ADDENDUM NO. 4

Project: Parking Access & Revenue Control System Equipment Procurement

Date: March 29, 2024

Dubuque, Iowa PARCS Procurement – Vendor Questions – March 29, 2024

Q-101

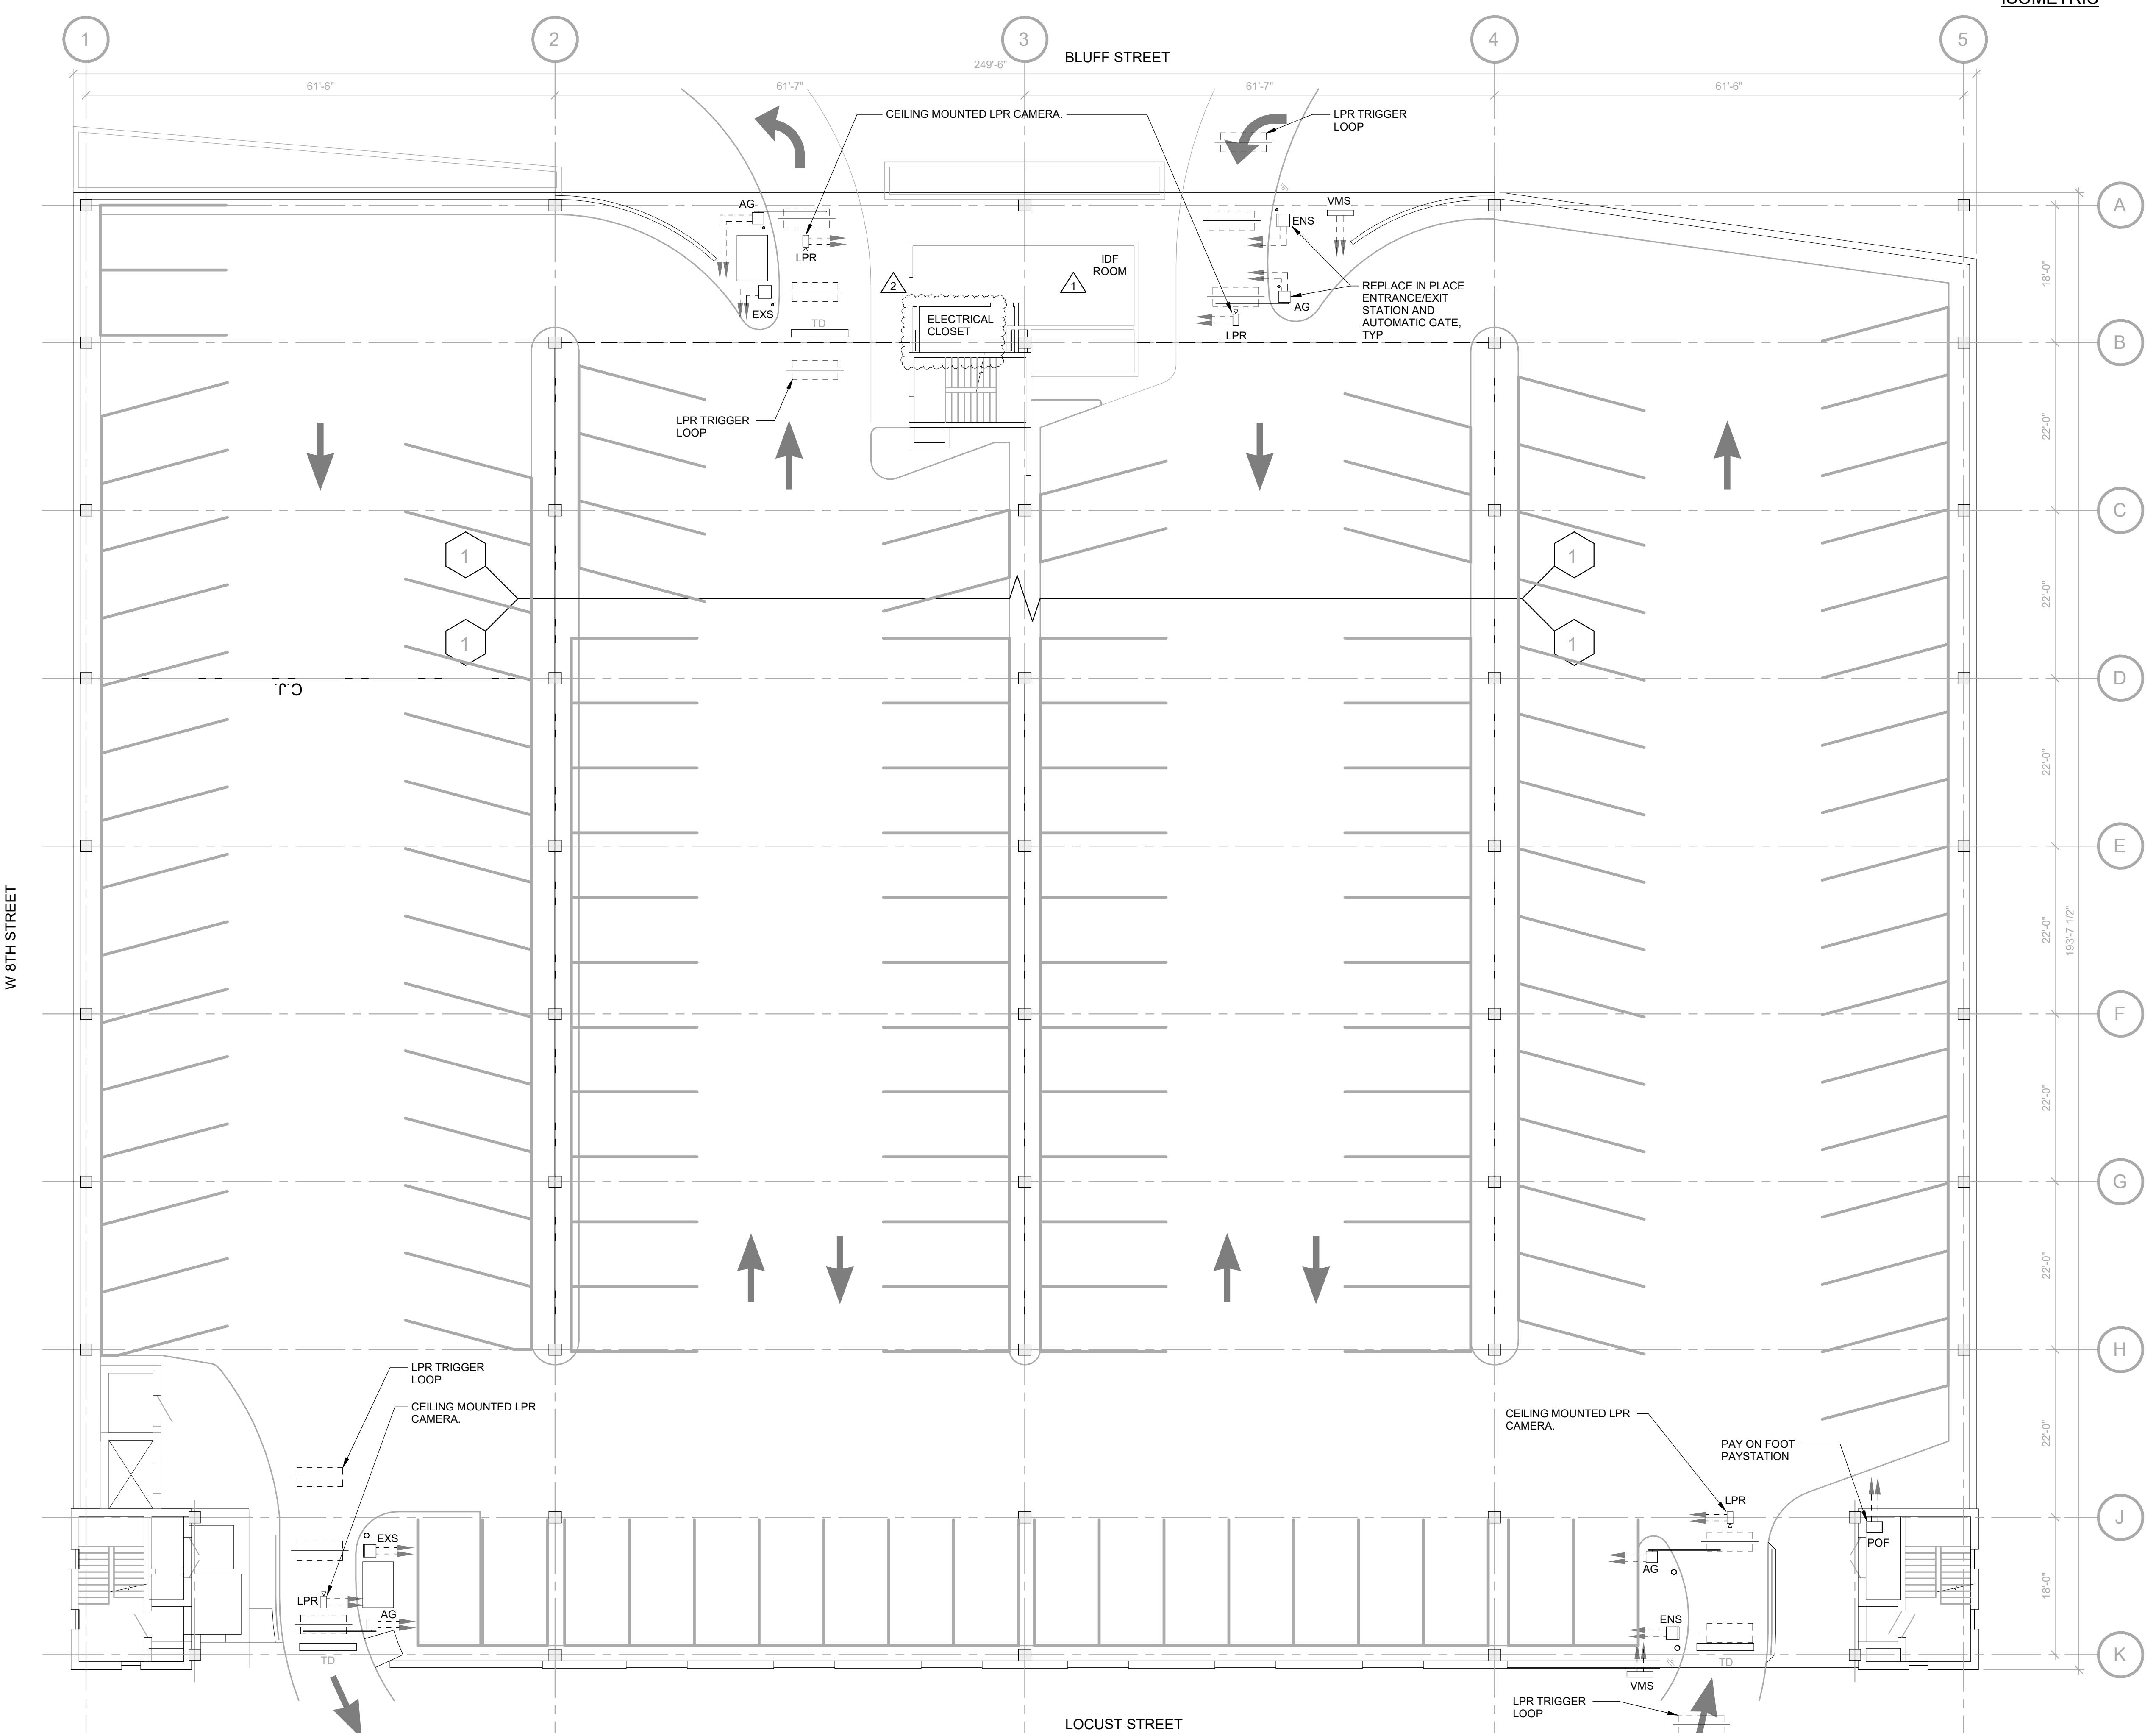
- b. For those lanes, if any, that are over 100ft from the IDF closets the current conduit runs from those lanes?
 - i. Example: Iowa Street Ramp, Q-101, shows the exit on to 6th Street. It would be good to know the closet or network drop.

This question was answered in Addendum 3. Vendors should presume conduit paths are available. Please provide a price per linear foot for rigid metal conduit, surface mounted, if deemed necessary due to documented hidden conditions at a later date.

Please see Addendum 4 construction plans for the most recent plan set.

SHEET TITLE: FIVE FLAGS RAMP 4TH TIER

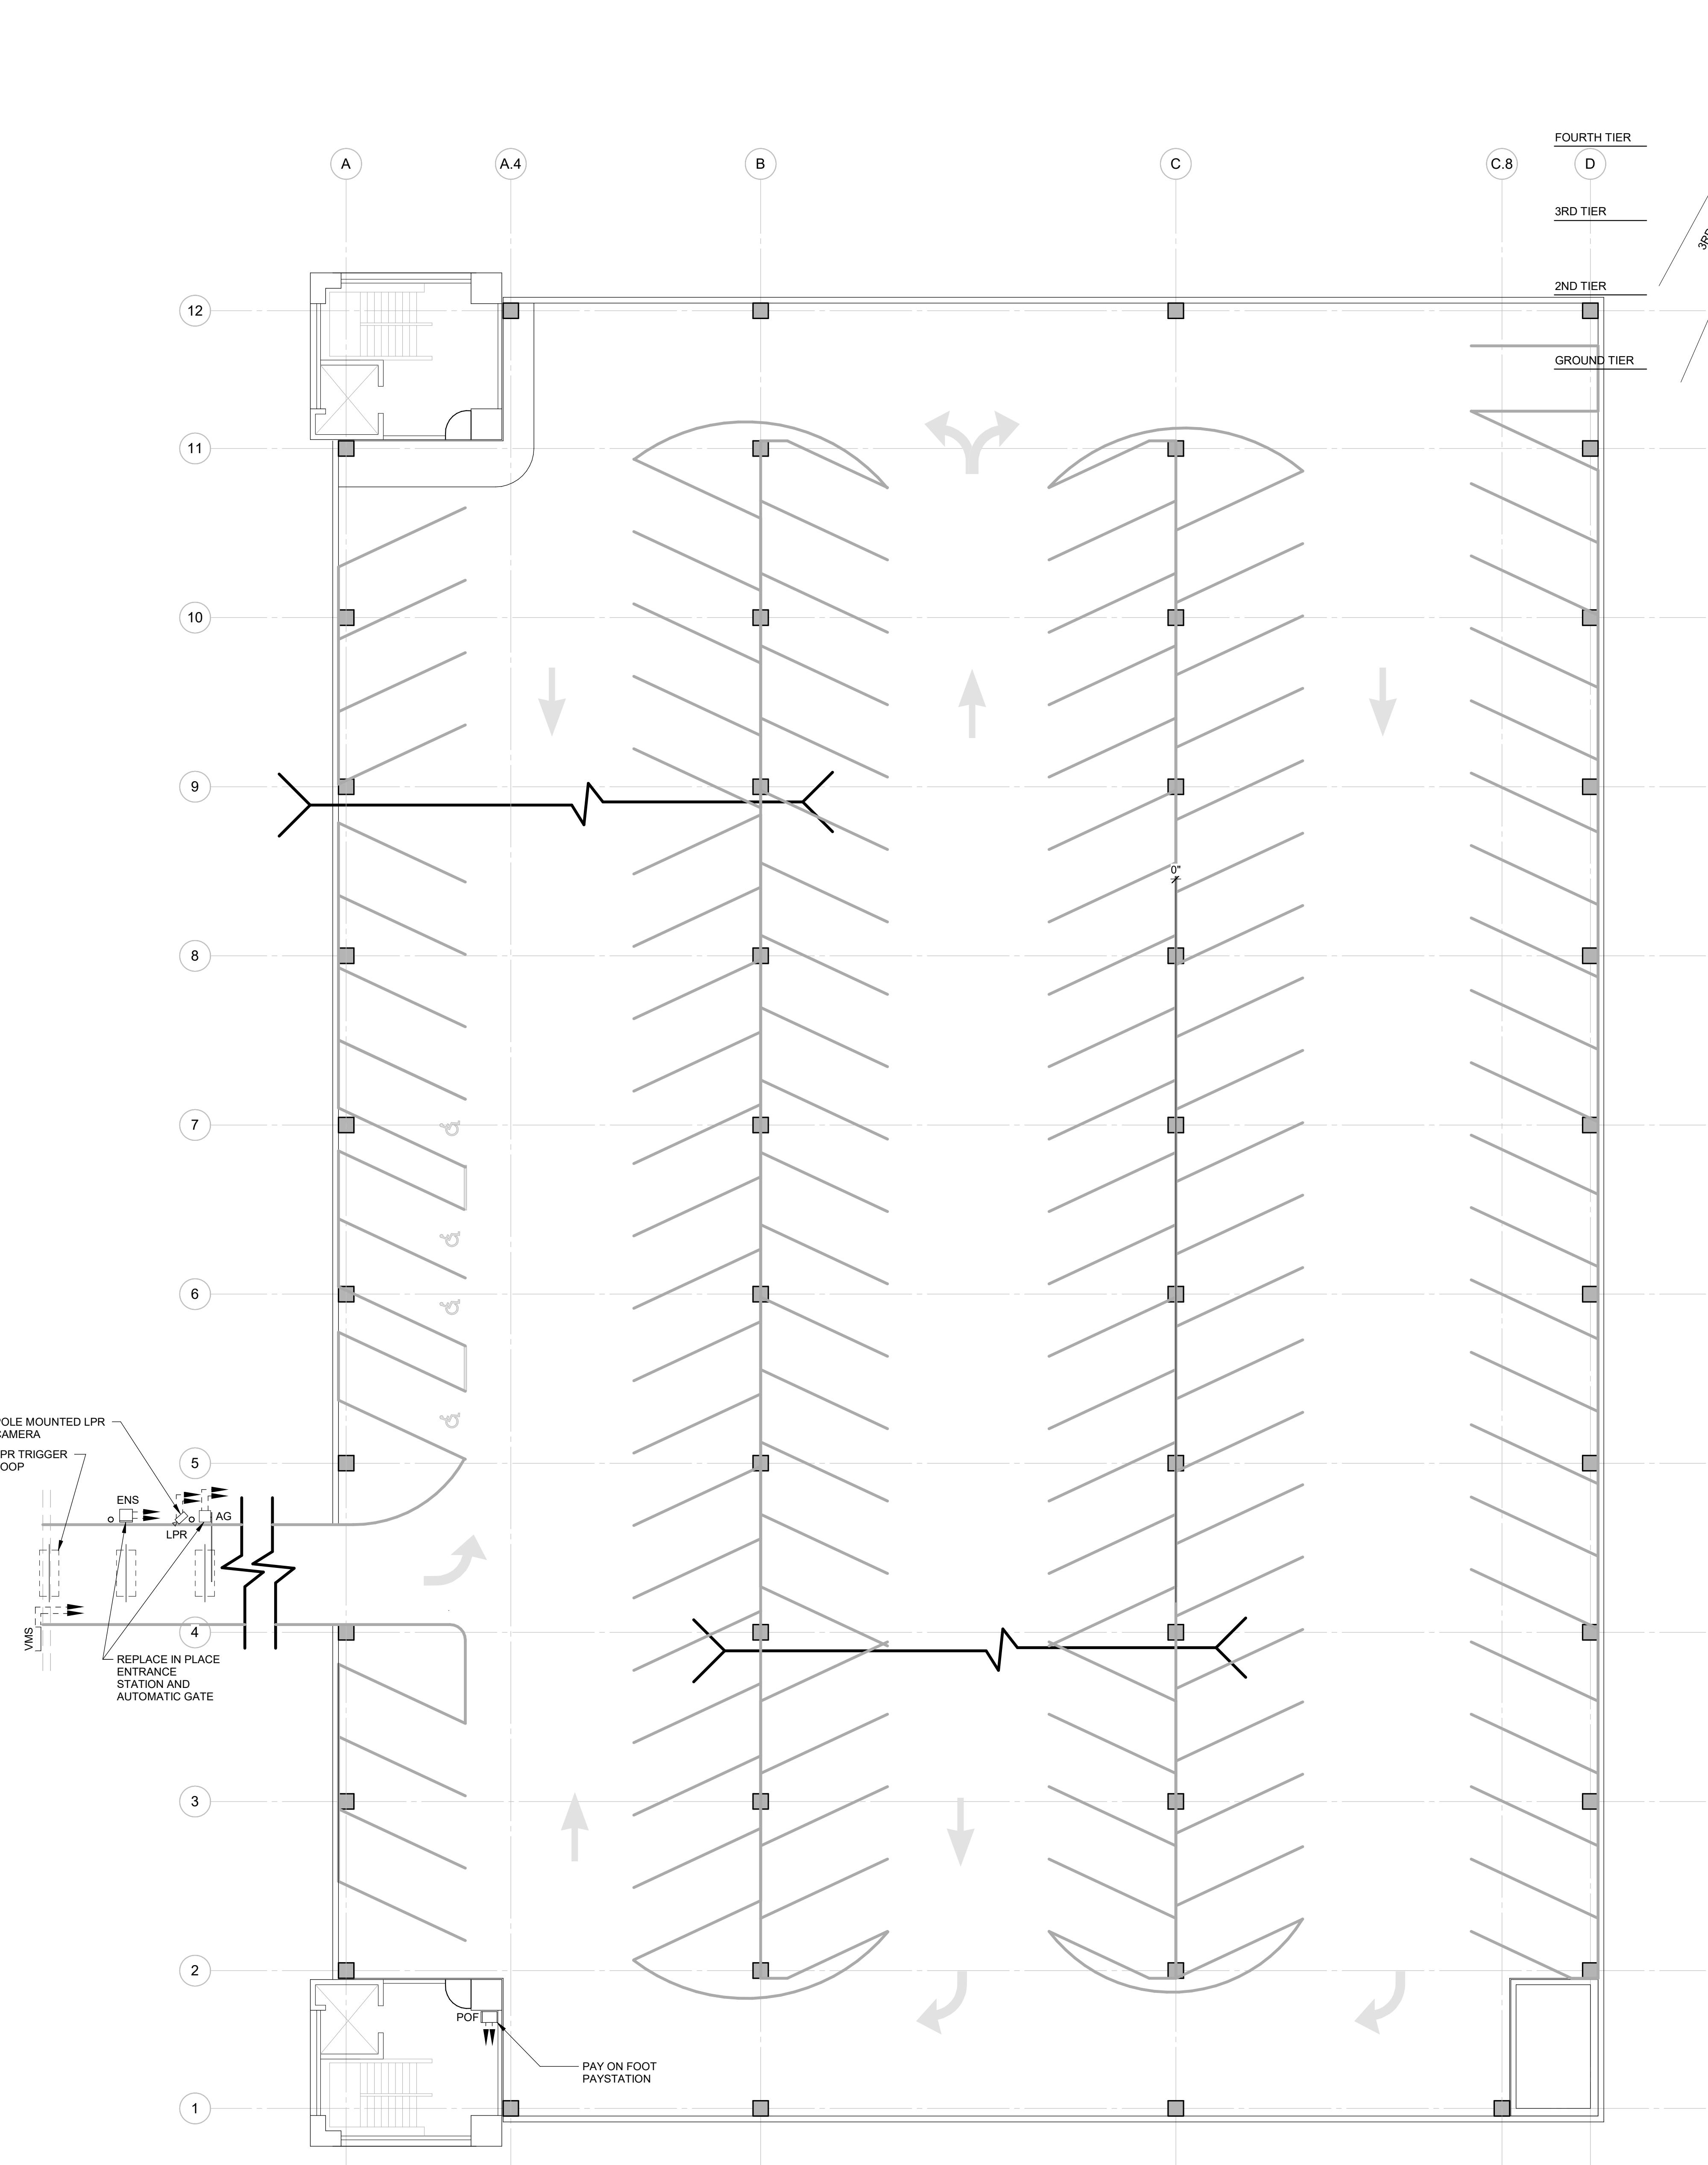
37. Has the location of the Five Flags 4th tier entry been finalized?

Yes, it will remain where it is presently located on the construction drawings. Addendum 4 construction plans represent the most recent plan set.
